ENGINEERING CLARIFICATION

EC TITLE: Filters and Adsorbers Drain Valves and Level Instrument Connection Details

PROJECT: 3 Kings Water Treatment Plant

EC NO.: 34

TYPICAL FILTER ISOMETRIC
1/2"=1'-0"

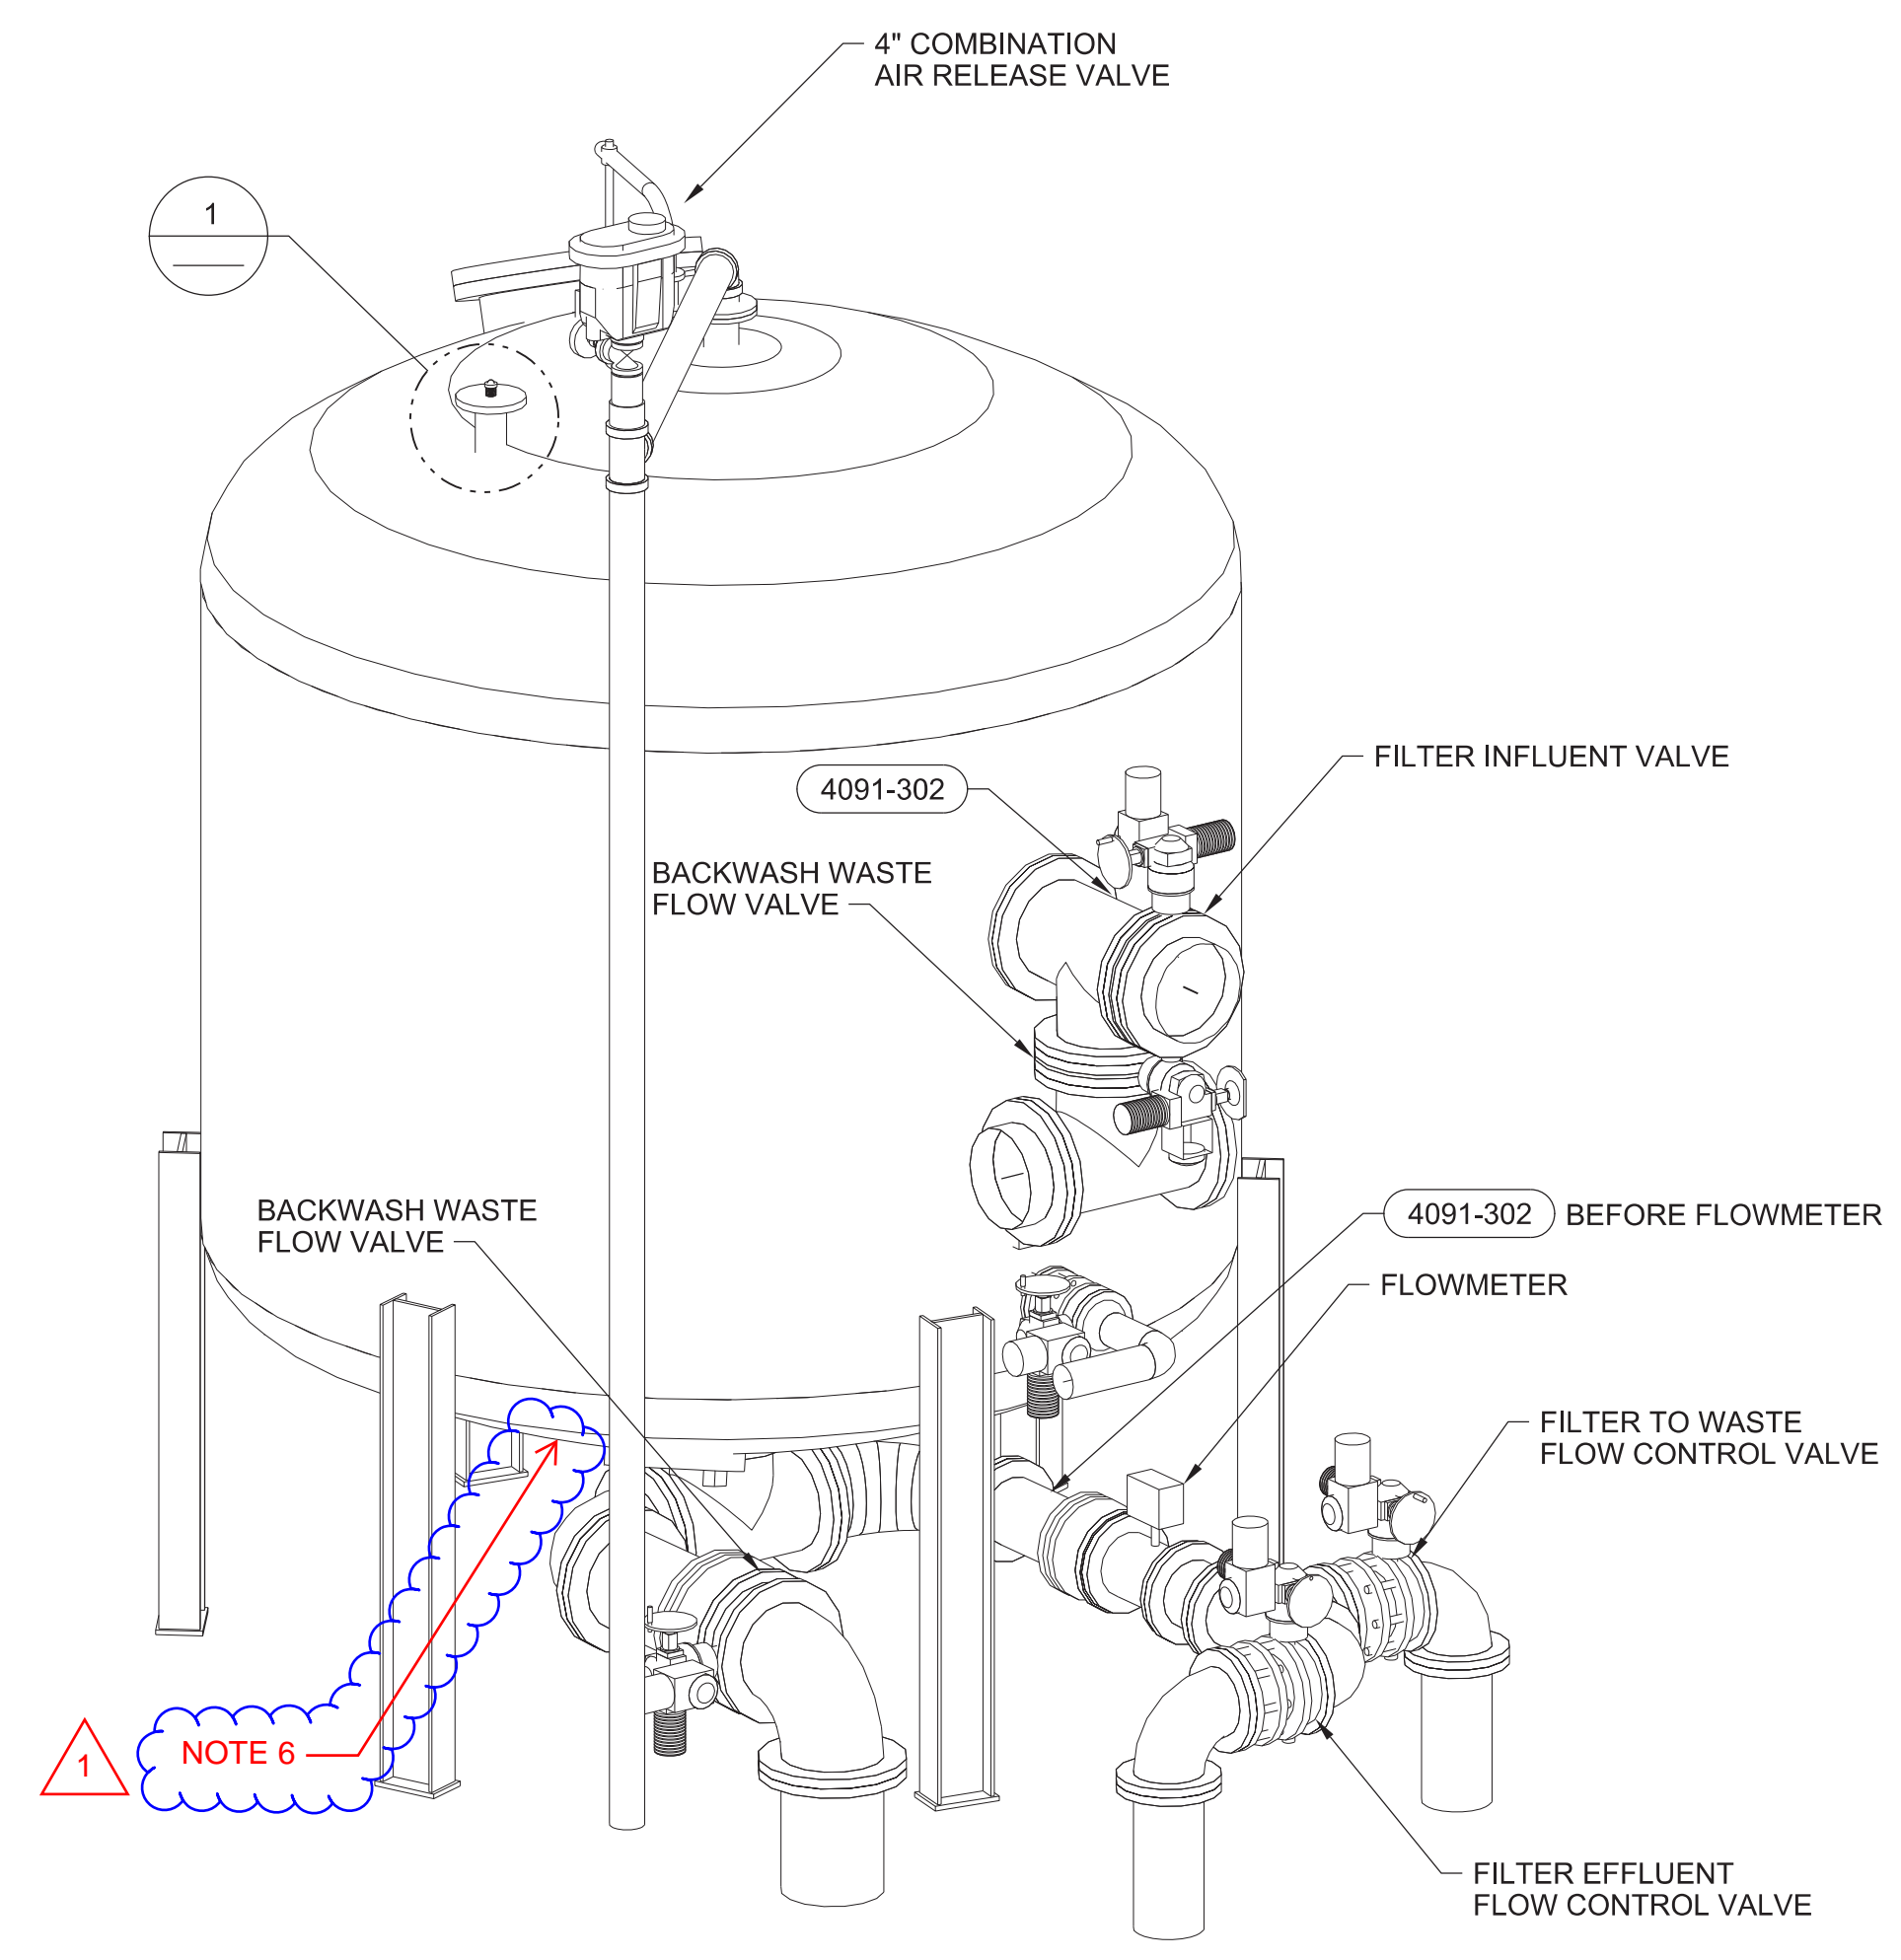
1. Drain valves on the underside of the filter and adsorber vessels are shown on the PIDs, but not on the process mechanical sheets. This clarification provides details on valve type and drain piping underneath the filters and adsorbers.
2. Echosmart connection detail did not show the flange connected to the top of the tank. Also, clarifications to material type are now included.

See attached revised drawing.
